AMENDMENT OF SOLICITATION/MODIFICATION OF CONTRACT				1. CONTRACT ID CODE	PAGE OF PAGES	
				J	1	23
2. AMENDMENT/MODIFICATION NO. 0003		3. EFFECTIVE DATE 15-Oct-2003	4. REQUISITION/PURCHASE REQ. NO. W81G67-3036-4923		5. PROJECT NO.(If applicable) DACW37-03-B-0007

14. DESCRIPTION OF AMENDMENT/MODIFICATION (Organized by UCF section headings, including solicitation/contract subject matter where feasible.) Bid opening date remains unchanged Wage Determination No. MN030061 dated June 13, 2003 is clarified. Contract clause 52.211-10 is amended. Drawings and Specification are amended. Bid Item 9AB in Section 00010 is changed from quantity 155,000 to 135,000.						
Except as provided herein, all terms and conditions of the document referenced in Item 9A or 10A, as heretofore changed, remains unchanged and in full force and effect.						
15A. NAME AND TITLE OF SIGNER (Type or print)				16A. NAME AND TITLE OF CONTRACTING OFFICER (Type or print)		
				TEL:	EMAIL:	
15B. CONTRACTOR/OFFEROR		15C. DATE SIGNED	16B. UNITED STATES OF AMERICA		16C. DATE SIGNED	
_____ (Signature of person authorized to sign)			BY _____ (Signature of Contracting Officer)		15-Oct-2003

Reach 1 From Sta F 120+12.88 To F

Continued from (Changes to the Drawings:) R-P-GF-12/225 Plan 2

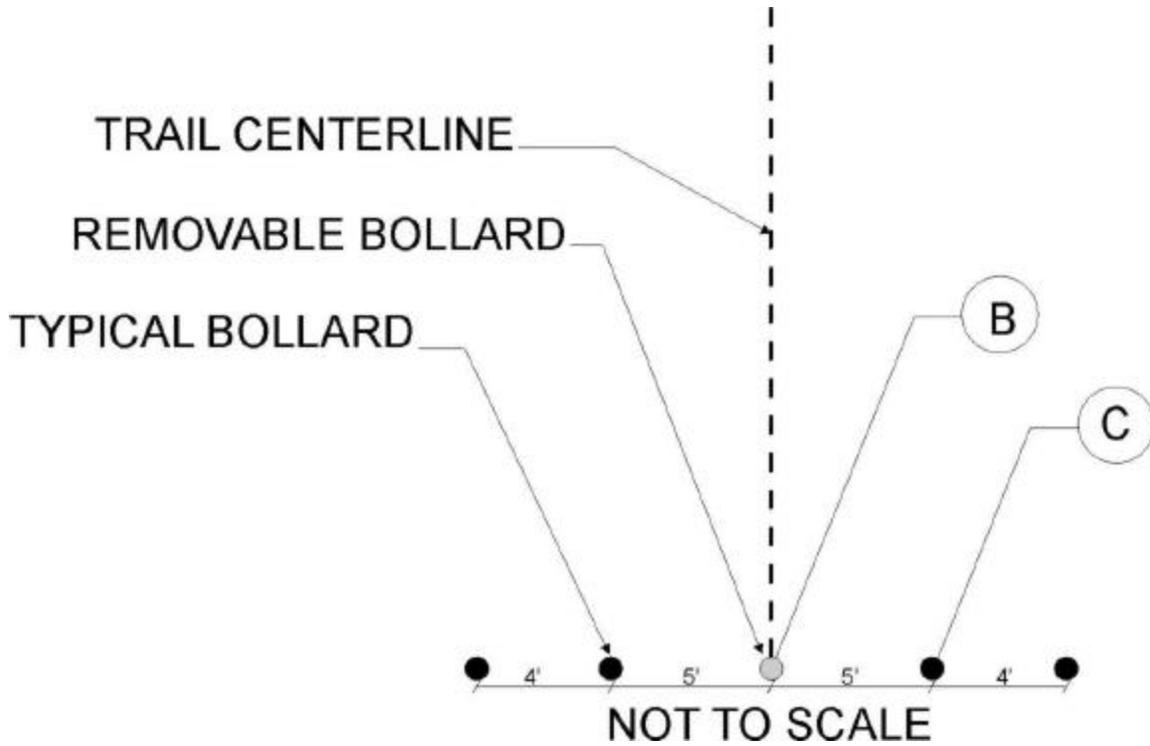
- Drawing R-P-GF-12/225 Plan 2 – Bollard Plan. Plan 2 (Bollard Plan) shows 3 bollards for entrances to recreational trails. Revise Bollard Plan to show 5 bollards at trail entrances as shown in attached sketch. The additional bollards shall be the type indicated on Detail C, drawing R-P-GF-12/225. One additional bollard shall be placed 9 feet from the trail centerline on each side of the trail, inline with the other bollards.

Note: See Drawing attached at the end of this amendment
